Review of Plans: Ferrante Site Plan, 1031 Route 9W, Upper Grandview, NY
Section 71.09 Block 1 Lot 17 R-22 zone

Subject: **Ferrante Site Plan**
1031 Route 9W, Upper Grandview
71.09/1/17; R-22 zoning district

As-Built Pool Site Plan package as prepared by Jay A. Greenwell, last revised 10/19/2022.

AS BUILT POOL SITE PLAN
FERRANTE
 1031 ROUTE 9W SOUTH
 UPPER GRANDVIEW, TOWN OF ORANGETOWN
 STATE OF NEW YORK
JAY A. GREENWELL, PLS, LLC
 SURVEYING - LAND PLANNING
 85 LAFAYETTE AVENUE, SUFFERN, NEW YORK, 10901
 PHONE 845-357-0830 FAX 845-357-0756
 © 2021 GREENWELL SURVEYING, 2020

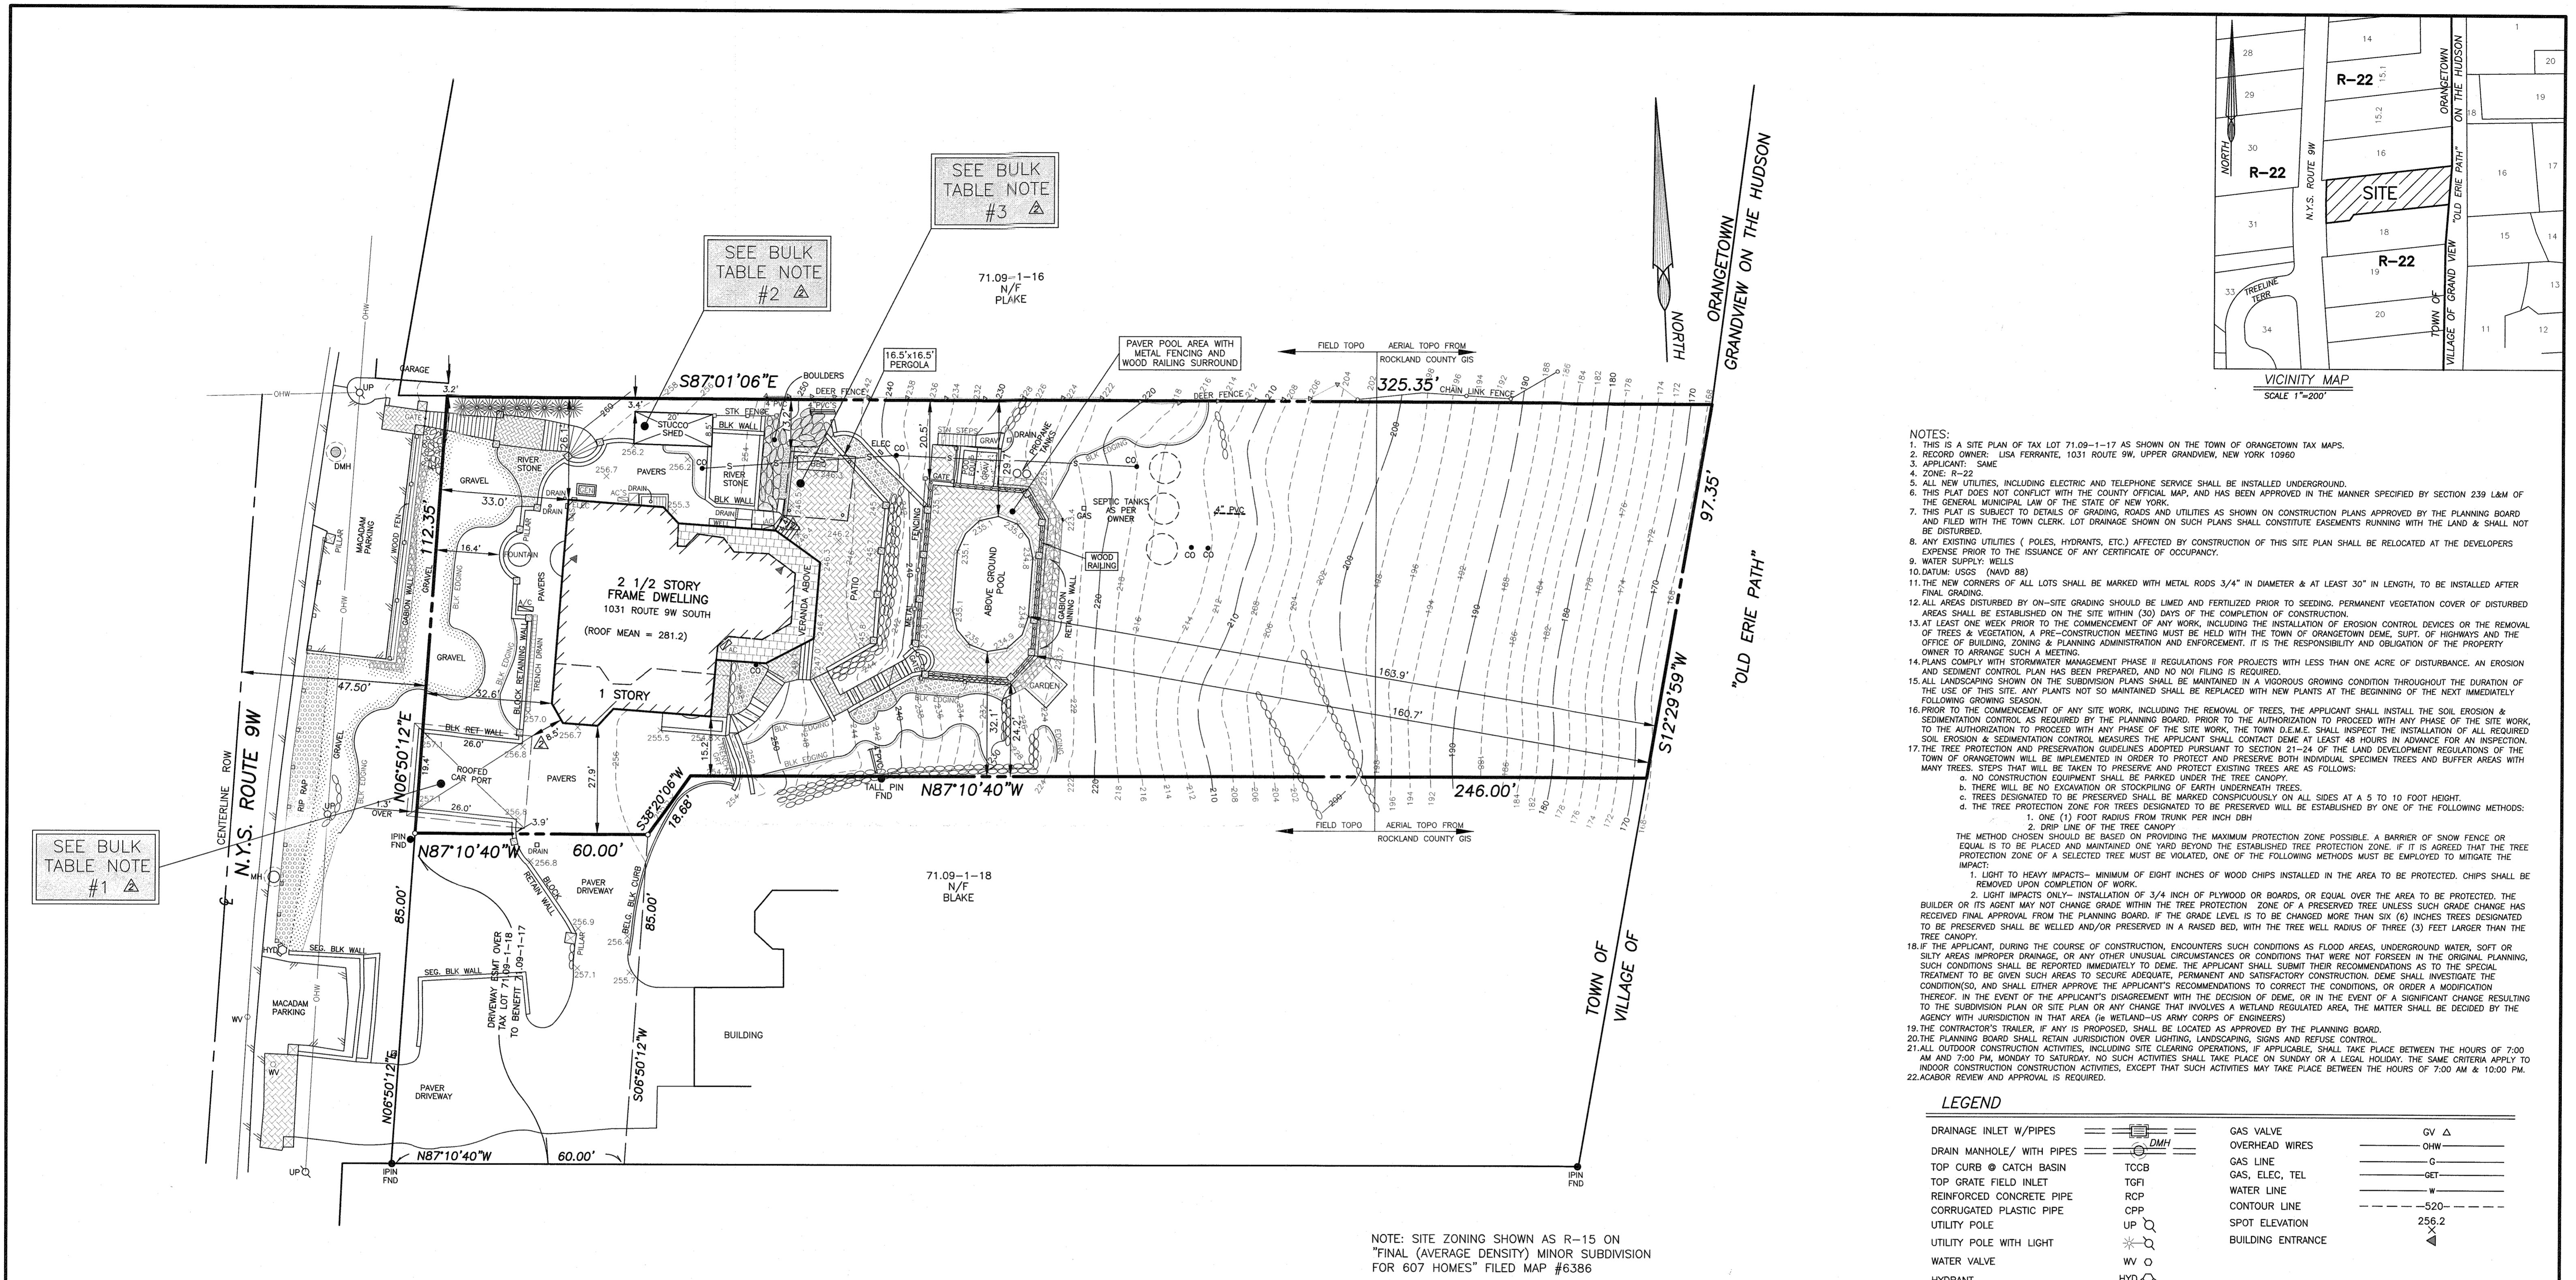
- 1) The Roofed Car Port is shown as being located 1.3' over the property line on 9W. The structure must be removed or obtain approval from NYS.
- 2) The following variances are required:

- a) Per Chapter 43, Article V, section 5.227, "A building or structure... accessory to a single-family... may be located in any required rear yard or side yard..." Variance required for accessory structure located in front yard.

- b) The car port is located 8.5' from the main dwelling, per Chapter 43, Article V, section 5.153; Location of accessory buildings ...no accessory building ... shall be closer to any principal building ... than a distance equal to the height of such accessory building... and in no event less than 15 feet.

- c) The Stucco Shed is located 3.4' from the north property line with 5' required.
 - d) The Pergola is located approximately 4.4' from the main dwelling, per Chapter 43, Article V, section 5.153; Location of accessory buildings ...no accessory building ... shall be closer to any principal building ... than a distance equal to the height of such accessory building... and in no event less than 15 feet.

- e) The bulk table indicates that the FAR of .23 is an existing condition, however this is not factual as the roofed over carport, shed and pergola were constructed without obtaining the required permits and CO's. Per chapter 43, table 3.12, R-22 District, Column 4, max FAR permitted is .20 with .23 proposed.

- CAR PORT IS OVER THE FRONT LOT LINE. STRUCTURE MUST BE REMOVED OR MODIFIED, OR APPROVAL OBTAINED FROM NYS DOT. ADDITIONALLY, A VARIANCE IS REQUIRED FOR ACCESSORY STRUCTURE IN FRONT YARD (ACT. IV, SECTION 5.227). ALSO, VARIANCE REQUIRED FOR PROXIMITY OF CARPORT TO DWELLING (REQ:15'; ACTUAL:9.5'); ART. V, SECTION 5.153.
- SHED AT NORTH PROPERTY LINE REQUIRES A SIDE YARD VARIANCE.
- VARIANCE REQUIRED FOR PROXIMITY OF PERGOLA TO DWELLING (REQ.=15'; ACTUAL=4.4'); ARTICLE V, SECTION 5.153.
